## Attachment A - Submissions

**Submission to Port Kembla Outer Harbour Development Application  
MP 08-0249**

### **Port Kembla Outer Harbour Development (MP 08\_0249) – Submissions**

Figure 3\_Stage 2 and 3 Road and Rail Infrastructure works

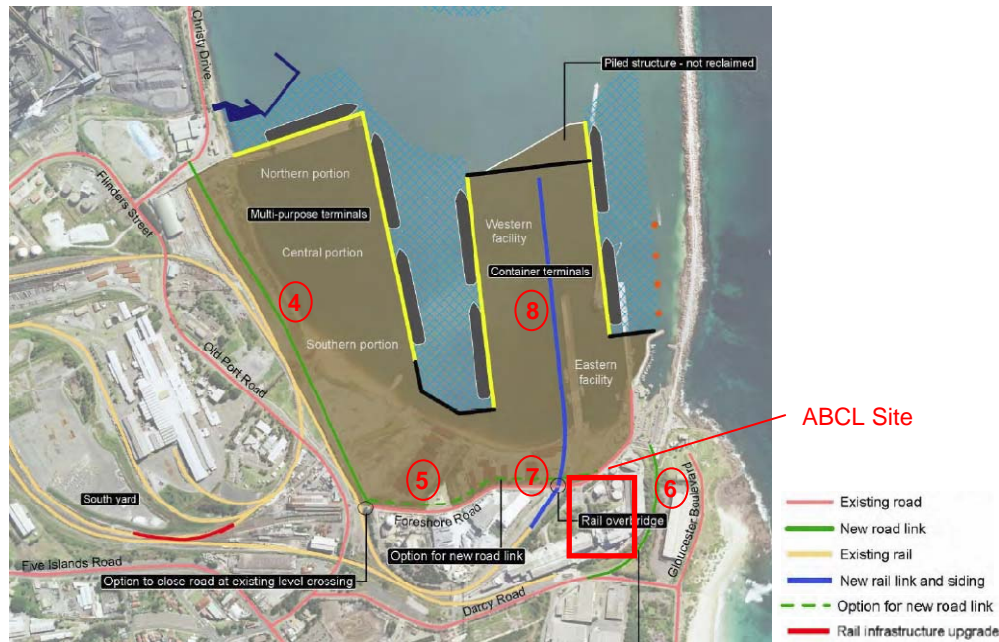
The Environmental Assessment largely refers to *potential* road and rail infrastructure requirements for Stages 2 and 3, rather than *proposed* upgrades based on assessments of requirements. The applicant is proposing that consideration of the required road and rail infrastructure is delayed until Stage 2 (Environmental Assessment, 2010:p18-4).

This submission considers that information on the required road and rail infrastructure upgrades to support the development is required now, at Concept Plan stage. The Director General Requirements issued for the project require the applicant to address traffic impacts during the construction and operational phases of the project, which must include “*recommendations for required infrastructure upgrades as a result of the development*”.

Figure 4\_Access to ABCL Site from Foreshore Road, showing distance to rail corridor

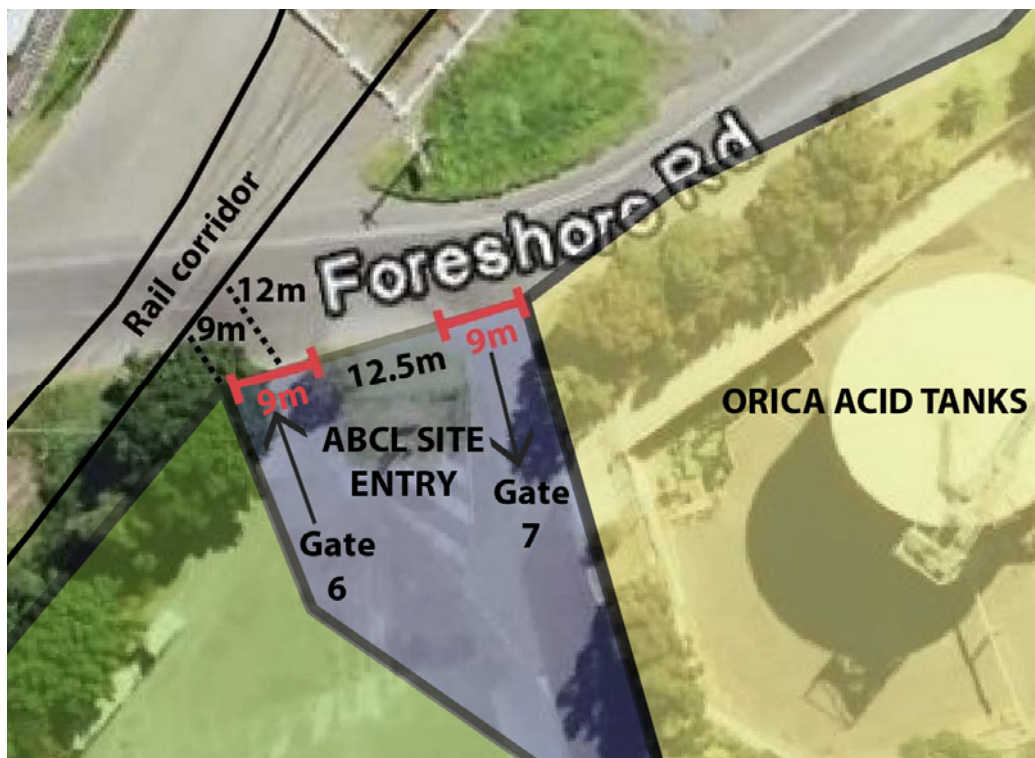
Our review of the proposed overbridge location indicates that the location is highly constrained. In order to provide a rail overbridge, the required ramping would likely require acquisition of part of the ABCL site which already has a very narrow access point. Alternatively, if a road bridge was proposed, the required ramping may block the existing entry point to the ABCL site.

Refer to Figure 4 which illustrates the extreme proximity of the rail lines to ABCL’s access point on Foreshore Road. This is the only possible access point to ABCL’s site.

As indicated in Figure 4, ABCL's gate is about 10 metres away from the point where the rail line intersects Foreshore Road. This is obviously going to make it difficult to construct any sort of rail/road overbridge while preserving access to ABCL's site.

*This reinforces that the proposed development requires significantly further detail for consideration prior to Concept Plan approval. It is requested that the Department of Planning require the applicant to submit additional information to ensure environmental impacts can be adequately understood prior to Concept Plan approval. It is considered of paramount importance that ABCL is consulted on this matter prior to approval of MP 08-0249.*

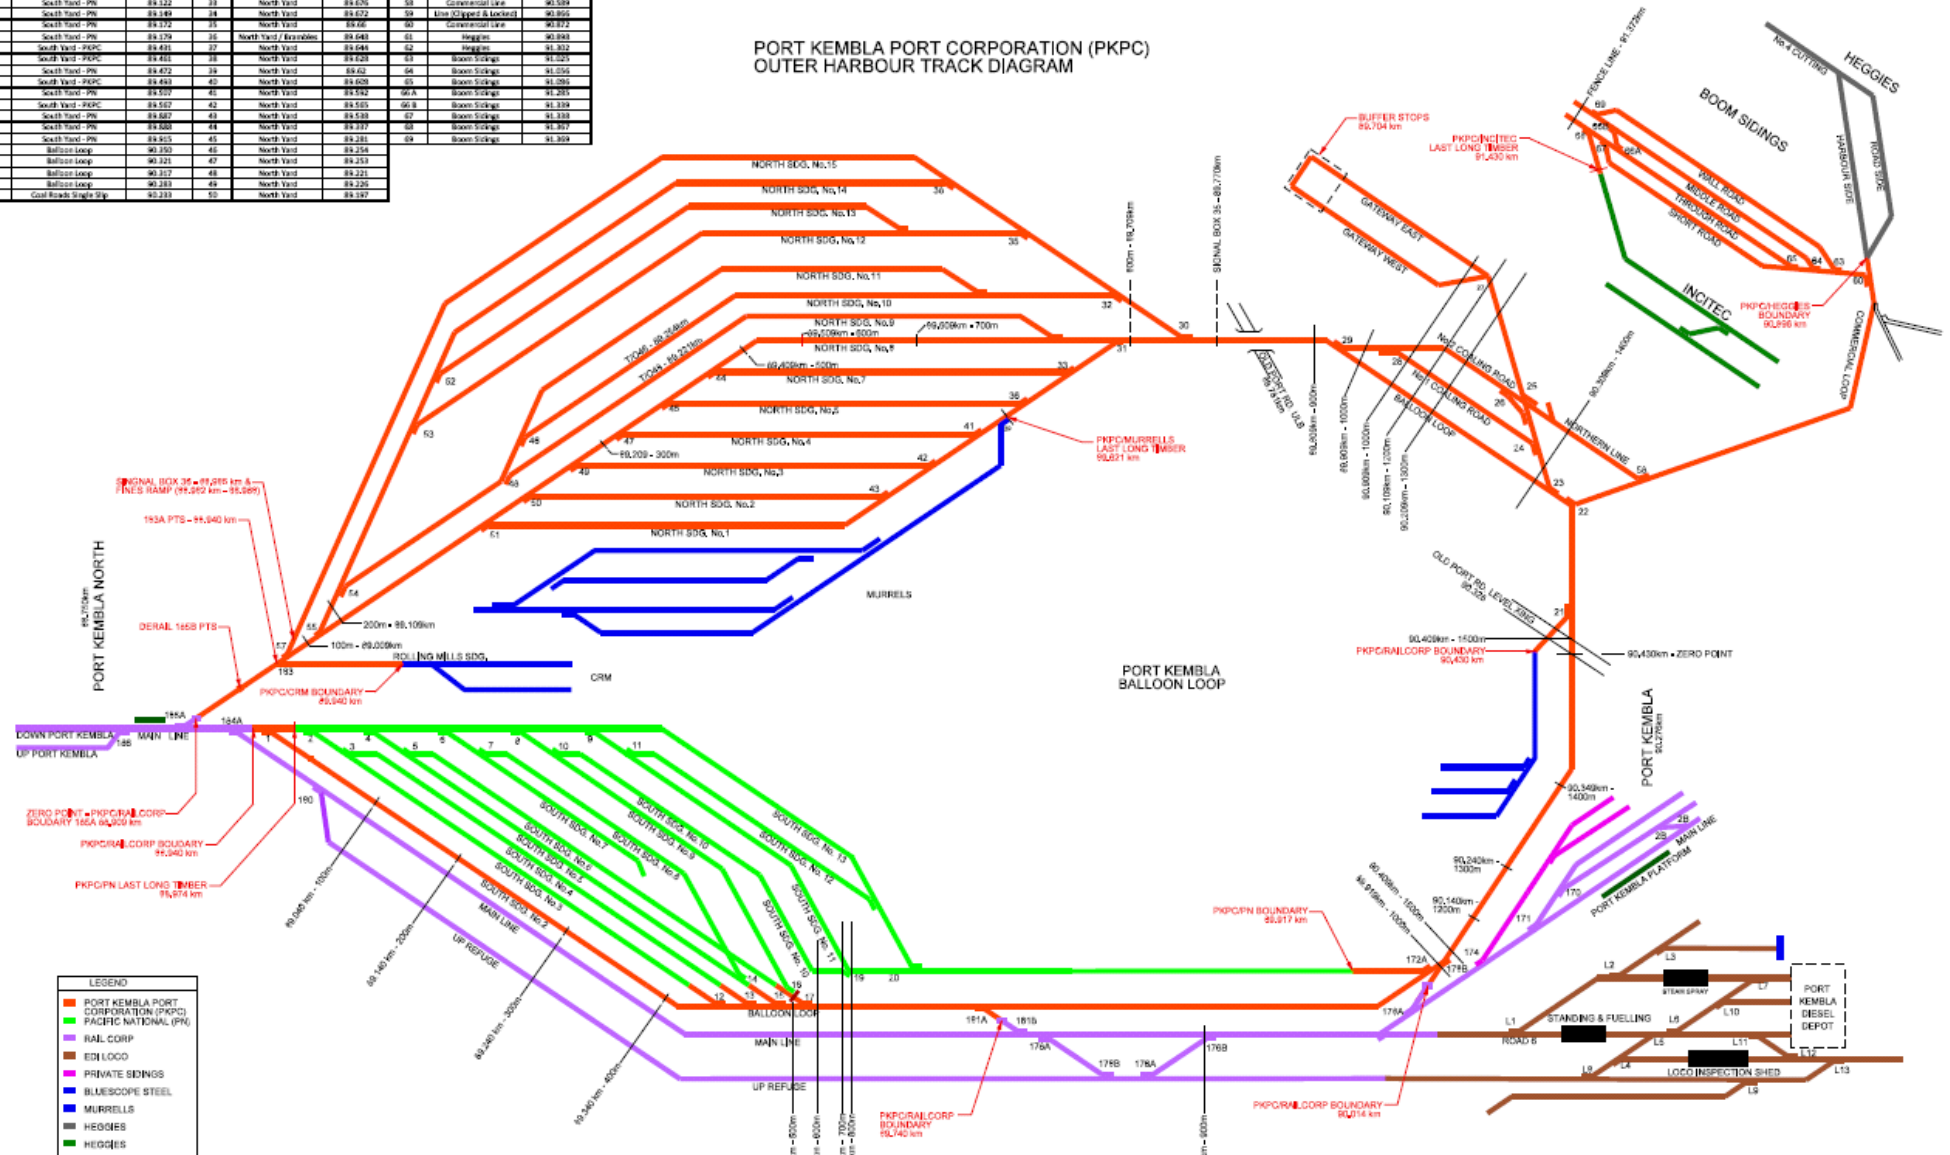
- Efficient rail access to Sydney is critical for growth in freight rail and the success of the outer harbour re development. It is not apparent that the necessary infrastructure requirements for this to happen have been addressed.

- The proposed rail overbridge at the entrance to the new quay poses particular limitations on road access to the port. Rail transport has very specific size limitations which do not restrict road transport movements. By having a rail underpass, road size limitations to the facility would be unimpeded. (E.g. a yacht could not pass under a rail overbridge on a truck, but could do so on a rail underpass.)

- The South Yard has been identified in the plan, but the North Yard appears to have been overlooked. Rail infrastructure and operations are highly interdependent and the absence of knowledge of these interdependencies places efficient usage of the infrastructure at risk.
